Environmental Impact Assessment (EIA) Ordinance, Cap.499
Application for Variation of an Environmental Permit
Project Title: Central-Wan Chai Bypass including its Road Tunnel and Slip Roads
(Application No. VEP-574/2020)

Pursuant to Section 13(5) of the EIA Ordinance, we have amended the Environmental Permit (No. FEP-07/364/2009/G). I attach the Environmental Permit as amended (No. FEP-07/364/2009/H) for your use.

FURTHER ENVIRONMENTAL PERMIT TO CONSTRUCT
A DESIGNATED PROJECT

Environmental Permit No. FEP-07/364/2009/H
環境許可證編號 FEP-07/364/2009/H

Figure 4c: Section of Direct Noise Mitigation Measures
 圖 4c：直接噪音緩解措施切面圖

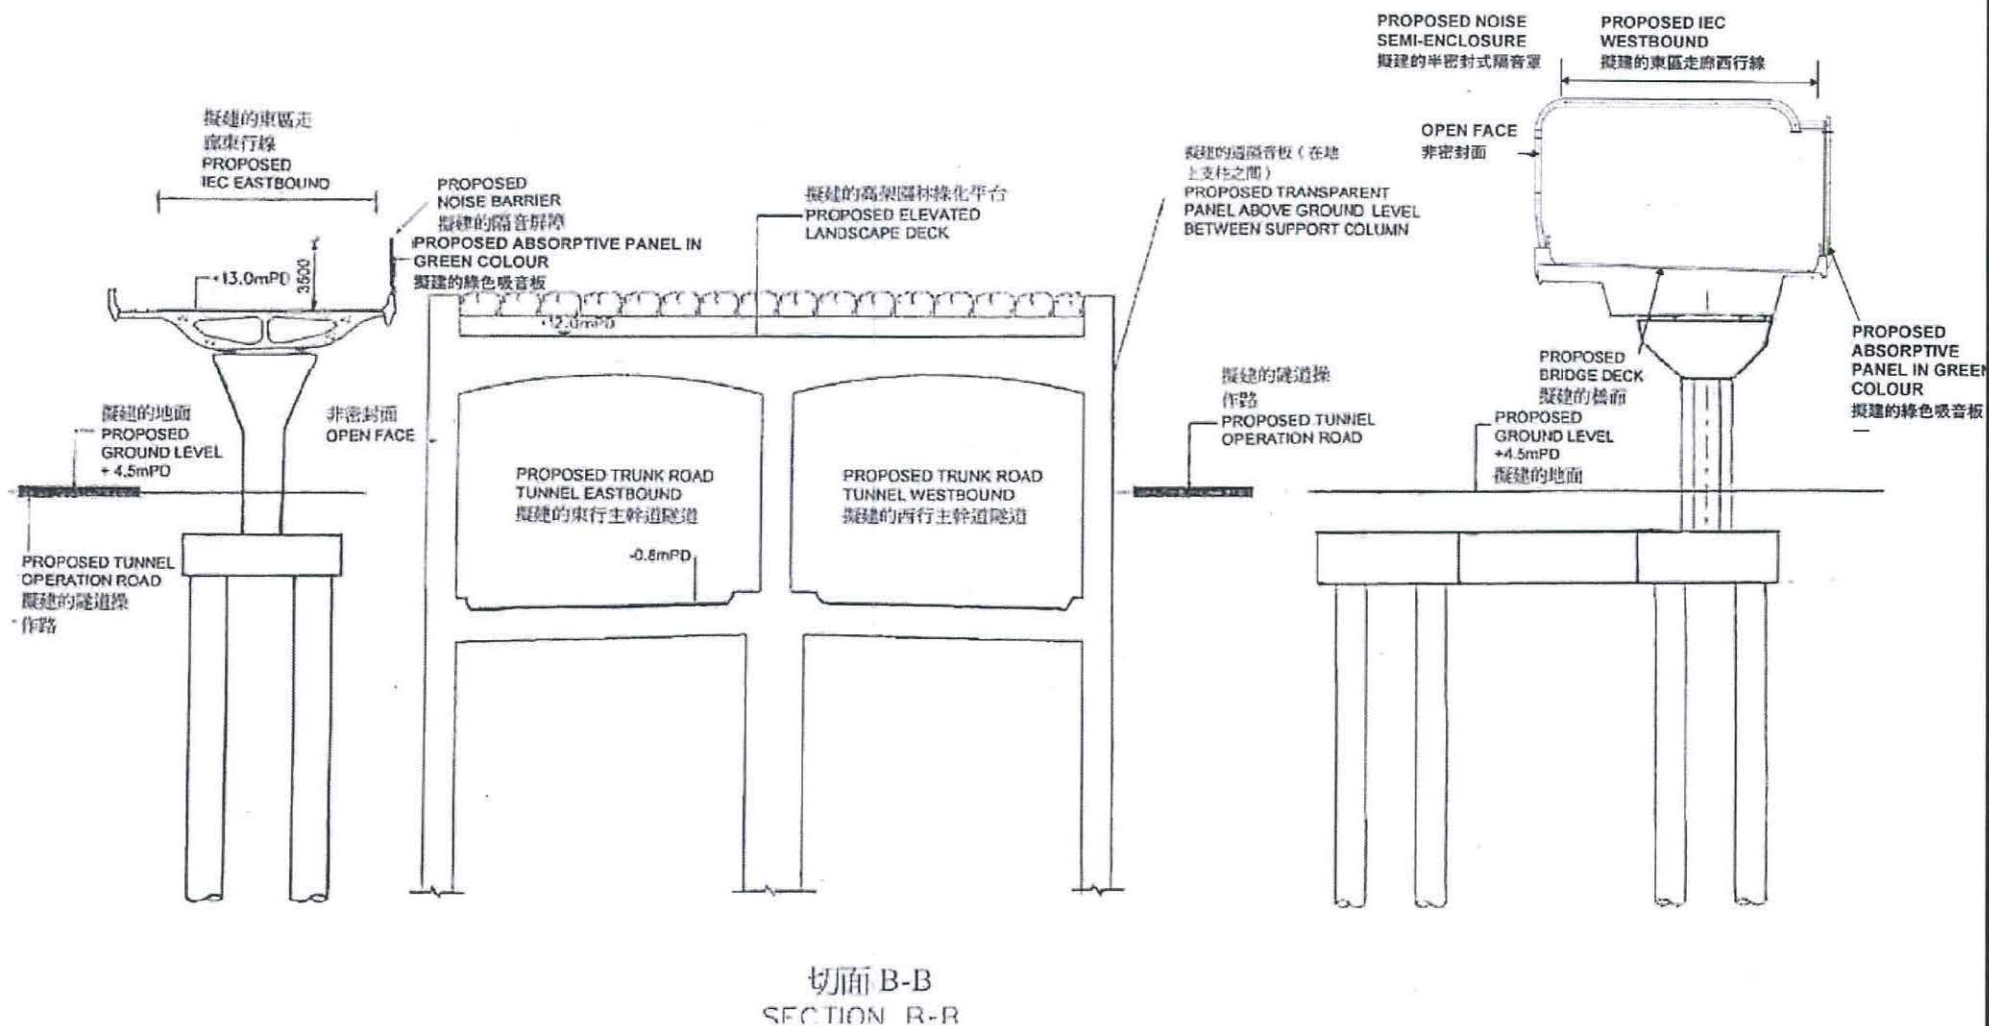
Application No. 申請書編號	Date of Application 申請日期	List of Amendments Incorporated into this Environmental Permit 已包含在本環境許可證內的 修訂項目	Date of Amendment 修訂日期
VEP-486/2015	6 November 2015 2015 年 11 月 6 日	Amend Condition 2.9, Figure 2 and Figure 3 of FEP-07/364/2009/A. 更改環境許可證編號FEP-07/364/2009/A第 2.9項條件，圖2及圖3.	24 November 2015 2015年11月24日
VEP-562/2019	10 May 2019 2019 年 5 月 10 日	Amend Condition 2.10 and Figure 4a of EP-07/364/2009/D in Part C. 更改環境許可證編號EP-07/364/2009/D第 2.10項條件及圖4a.	15 May 2019 2019年5月15日
VEP-566/2019	17 September 2019 2019 年 9 月 17 日	Amend Scale and Scope of Designated Project in Part B and Figure 1a of EP-07/364/2009/F. 更改環境許可證編號EP-07/364/2009/F B部 指定工程項目的規模和範圍及圖1a.	10 October 2019 2019年10月10日
VEP-574/2020	27 March 2020 2020 年 3 月 27 日	Amend Condition 2.14, Figure 4c, 4d, 4e & 4f of this Permit of EP-482/2013/B to reflect the latest design of absorptive panel in green color on the lower parts of Eastbound noise barriers and Westbound noise enclosures in Island Eastern Corridor Link. 更改環境許可證編號 EP-482/2013/B 第 2.11 項 條件、圖 2d、圖 2e、圖 2f 及圖 2g 以反映在 東區走廊連接路東西行線的半密封式隔音罩 及隔音屏下半部最新擬建的綠色吸音板設計.	22 April 2020 2020年4月22日

- (a) transparent panels, translucent panels and/or green roof with translucent skylight in the upper part where appropriate; and
 - (b) absorptive panels in green color in the lower part where appropriate,as shown in Figures 4c, 4d, 4e and 4f of this Permit. (see note 8)
